SERVICE LETTER

No. 373

Piper Aircraft Corporation

SUBJECT: Installation of Oil Shields on Airborne Mechanisms Dry Vacuum Pumps, Models 113A1 and 113A5

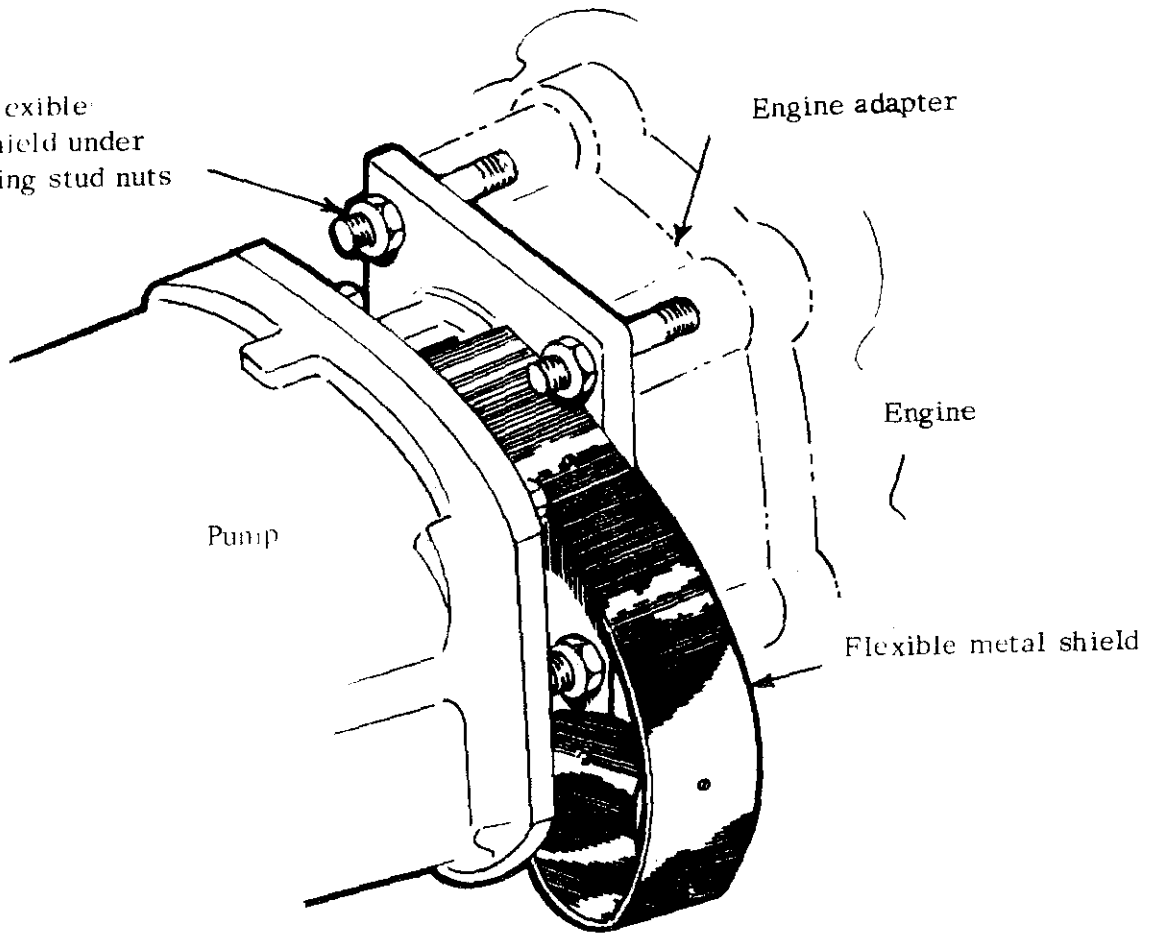
It has been determined that occasionally oil or cleaning solvents have entered the vent holes in the face of the mounting flange of the 113A1 and 113A5 Airborne Mechanisms dry vacuum pump.

A flexible metal shield, part number 756 143, which is easily installed by threading under the pump mounting bolts, has been designed to protect these openings. Removing the pump is not necessary and the shield does not require fastening as the spring tension of the shield will hold it in its proper position, once installed. Installation of this shield is recommended on the subject aircraft equipped with Airborne Mechanisms Dry Vacuum Pumps. See sketch on the reverse side of this letter.

During installation or removal of the pump, the shield should be removed to prevent damage to the shield.

Install flexible
metal shield under
4 mounting stud nuts

Vent holes to be
covered by flexible
metal shield
